**Subject:** City of Beverly, MA  
National Grid N-192, 115 KV Transmission Main Constructability Peer Review  
Draft Review Memorandum

## 1. Overview and Background

Figure 2 – Cross Section of Typical Railroad ROW with Existing Conditions

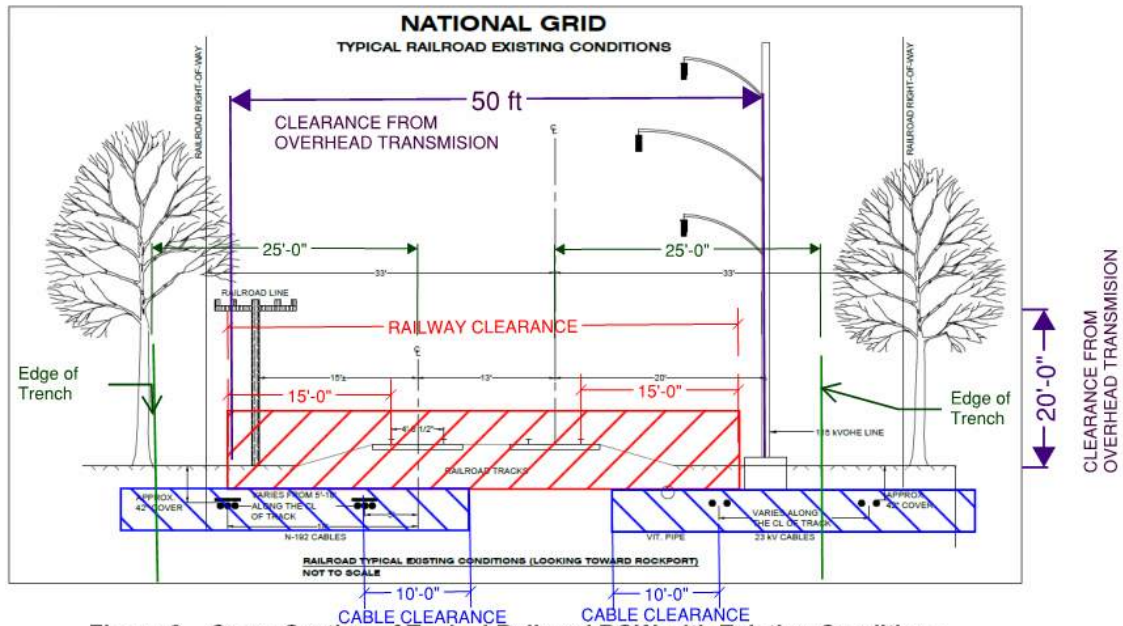
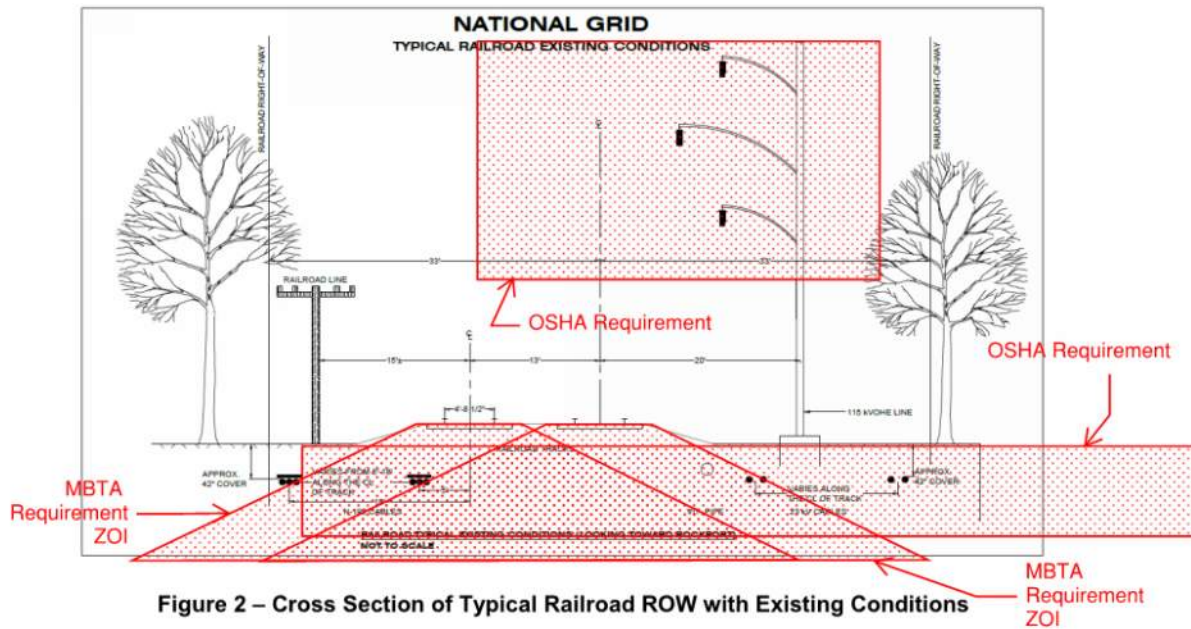
The exhibits on the next page identify locations the Directorate where construction is not prohibited without special approval. As reflected in the exhibits, there is not an apparent open area to install the new transmission line without obtaining variances and special approval from both the Directorate and OSHA standards.
